July 2007 IEEE Plenary Meeting

P802.1ah D3.6 comments

Alex Conta

Figure 25-1—Internal organization of the MAC sublayer in a PBBN

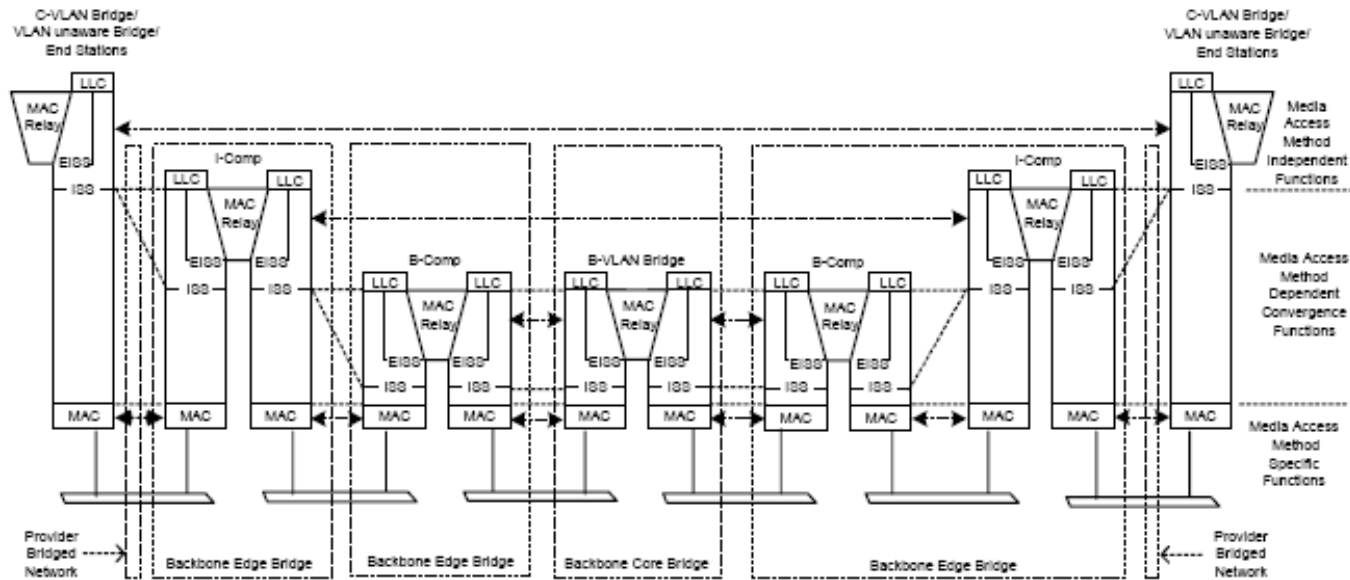
More accurate MAC in MAC illustration of Figure 25-1

Current level of complexity:

- number of elements required - ports and bridges

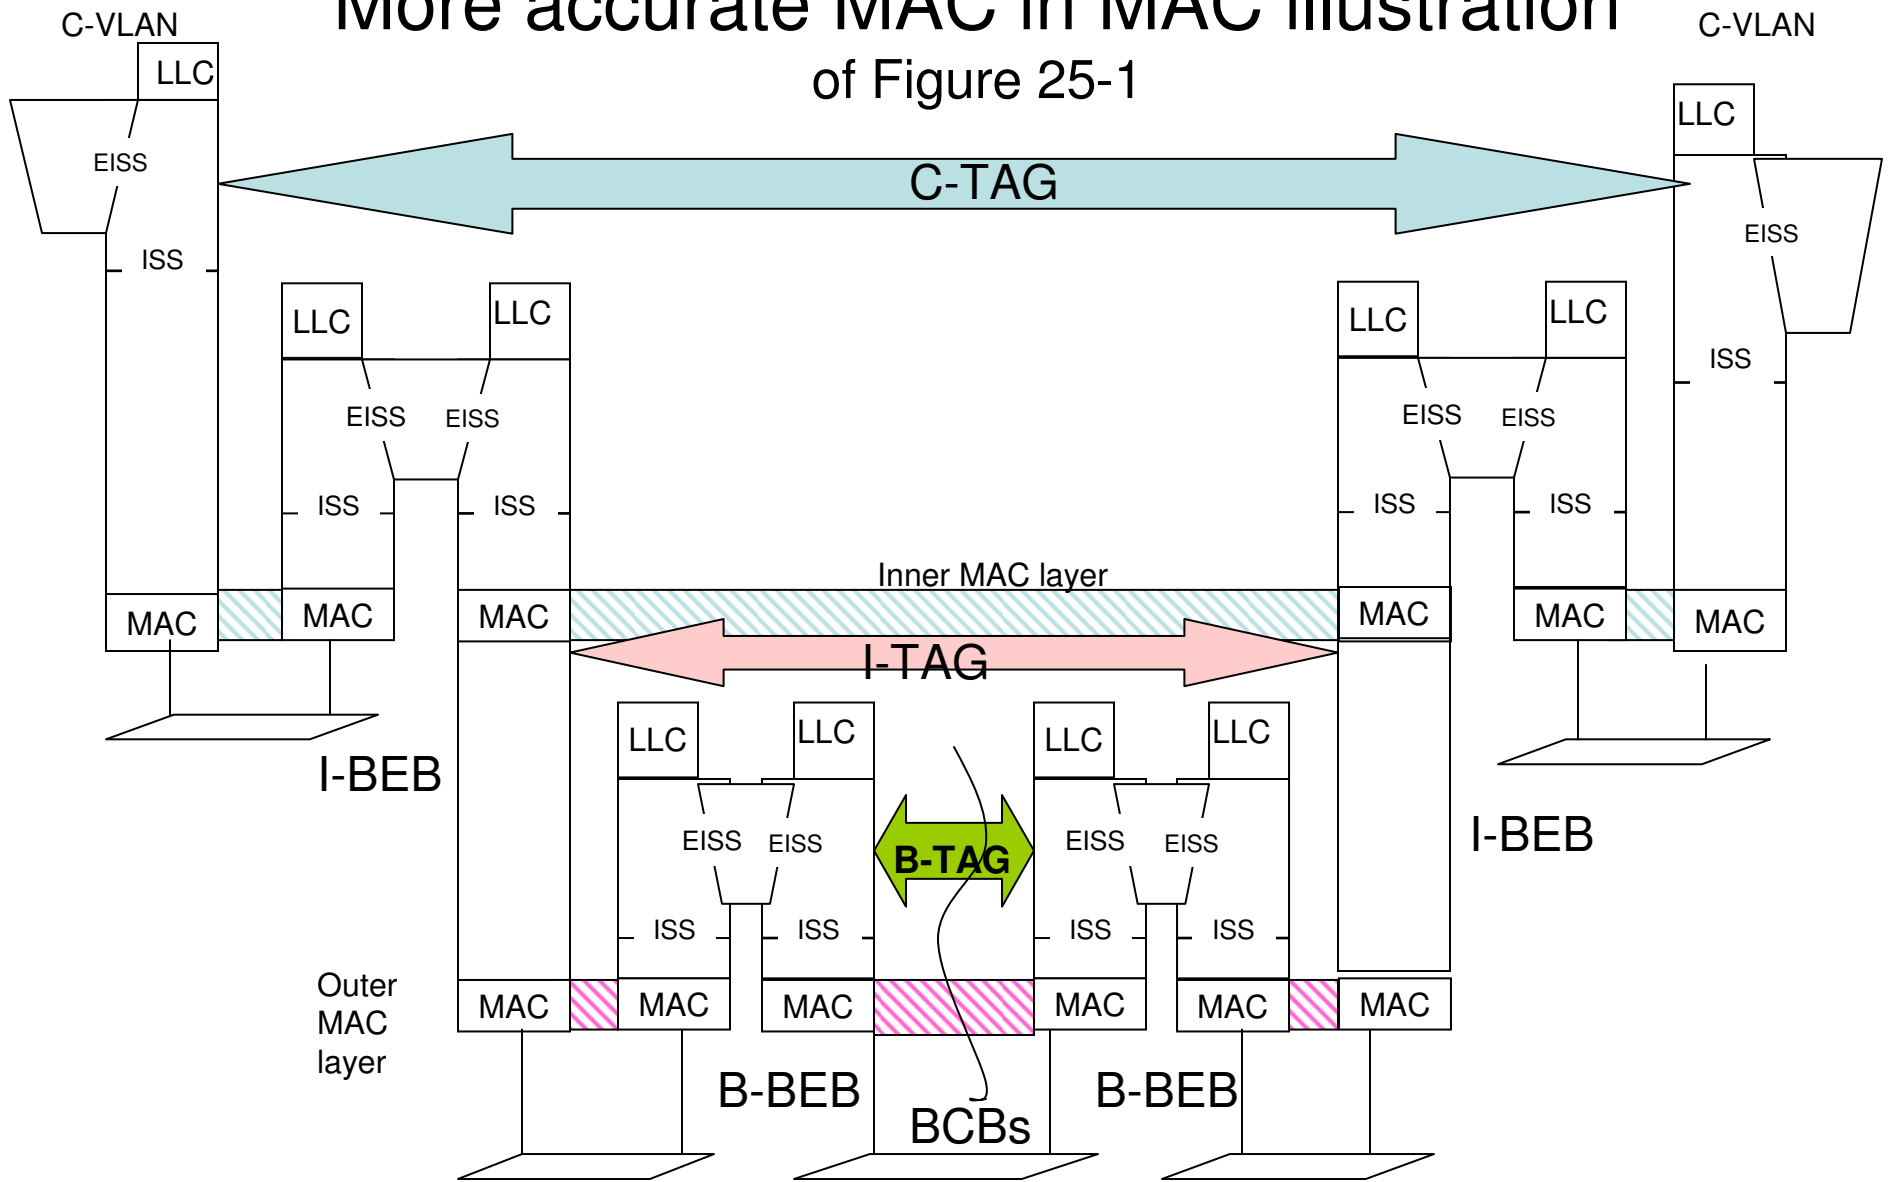
How MAC in MAC could/should
be illustrated

More accurate MAC in MAC illustration

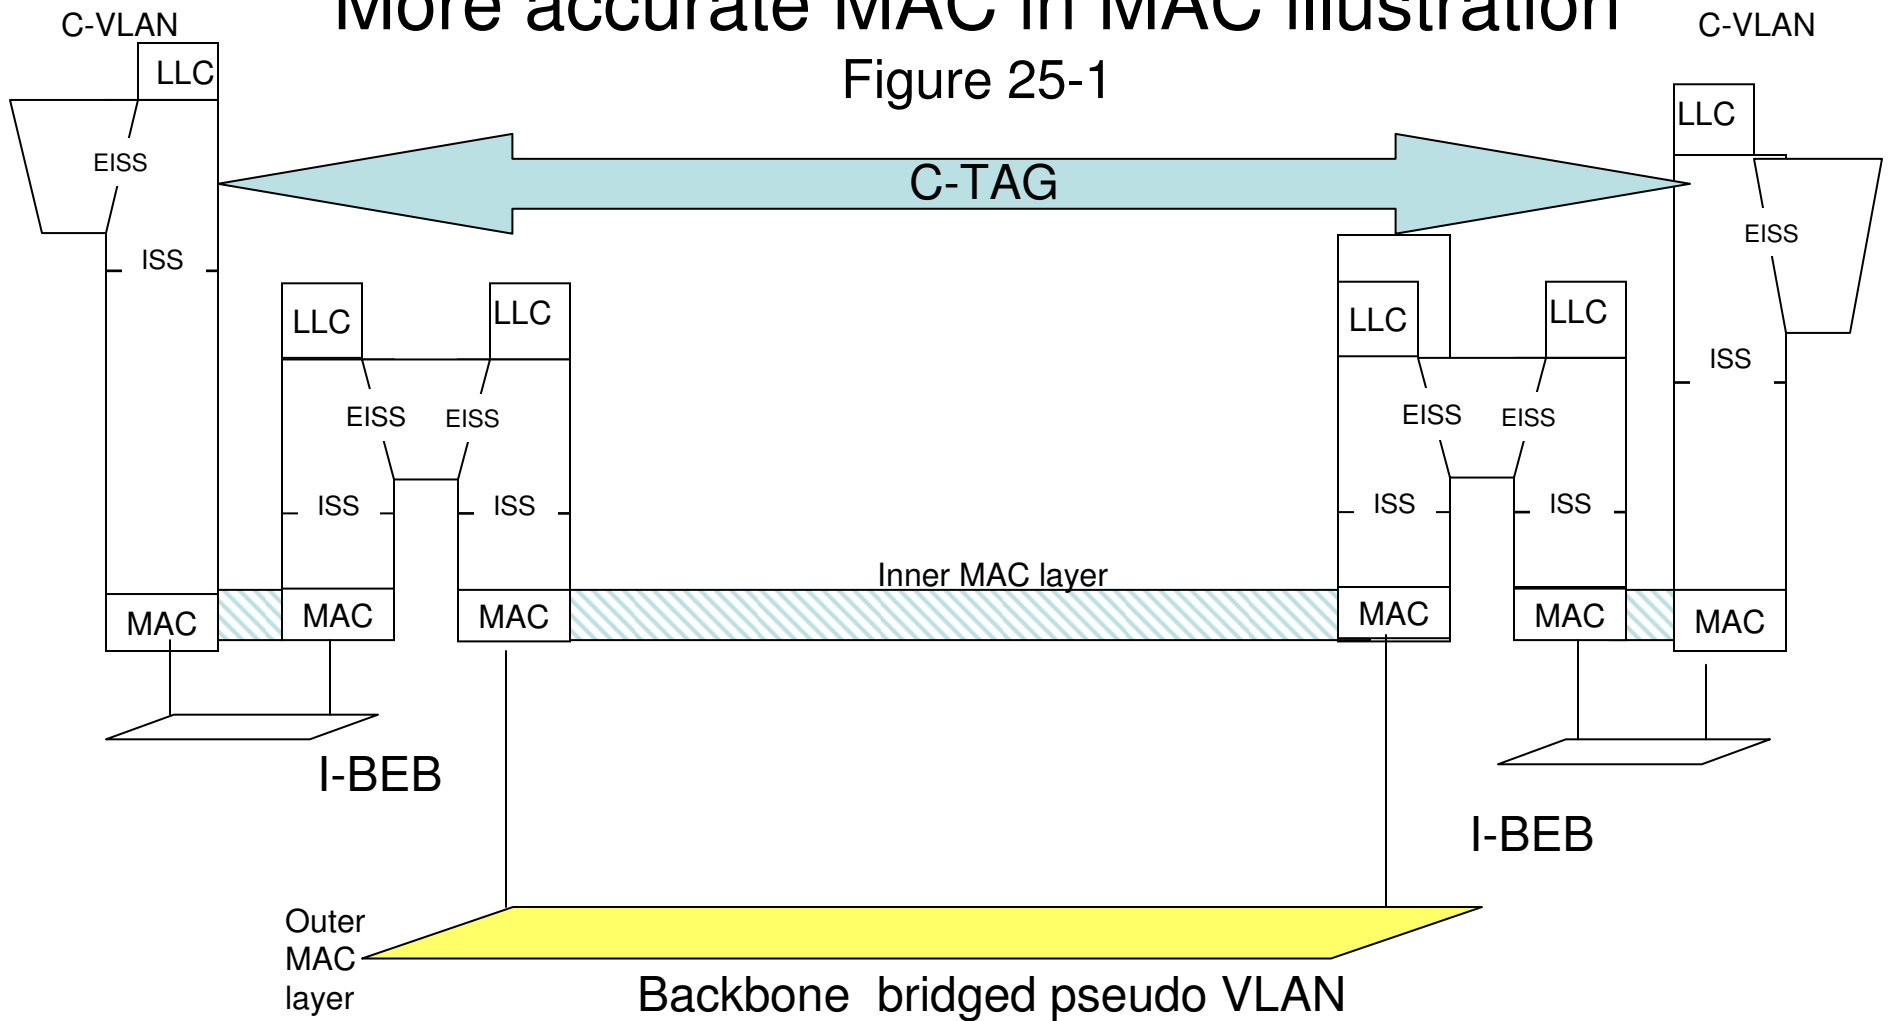
Figure 25-1

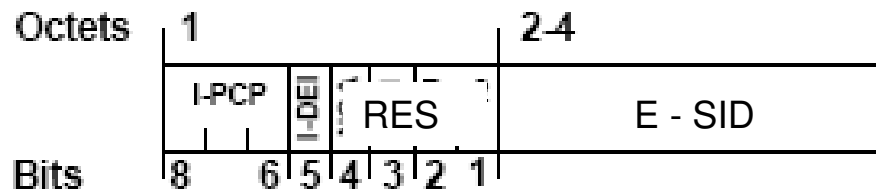
Change ITT to ETT

Split current I-TAG header into two
